December 17, 2018

Regarding: **Block 1201, Lots 5 & 6, Township of River Vale
Including Block 2001, Lot 1 and Block 2201, Lots 26 & 31, Borough of Hillsdale
Preliminary & Final Major Site Plan & Major Soil Moving Application
The Fairways at Edgewood, LLC**

Christopher P. Statile, P.E.
Planning Board Engineer

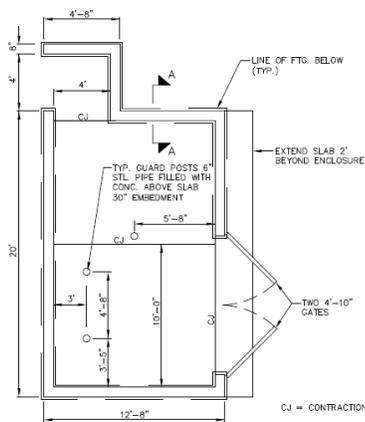
The parked vehicles in front of the affordable housing building will produce off-site headlight glare to the properties on the opposite side of Piermont Avenue. Therefore, affirmative shielding must be provided other than/in addition to landscaping.

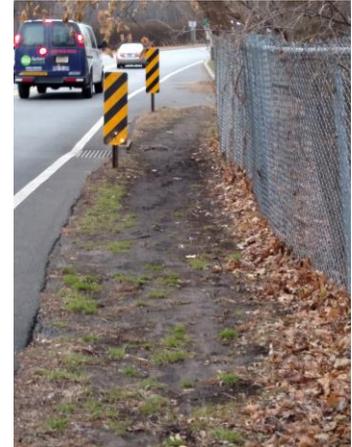
The improvements provide turn lanes and traffic islands. We raised a concern about the new pedestrian crosswalk with the County. With the westerly pedestrian crosswalk bifurcated, the school crossing guard must separately ‘herd’ school children onto the new traffic island, and then guard/cross the second roadway. It’s a large length of separated traffic lanes to be controlled with one part-time guard.

We recommend to the County that a push button flashing warning beacon be provided at the intersection to advance warn drivers of the crossing of pedestrians. The County is amenable to such a precautionary initiative. This was recently installed in downtown Hillsdale after a pedestrian fatality had occurred and are found through-out the State.

The crosswalks should also be colorized for greater motorist visibility.
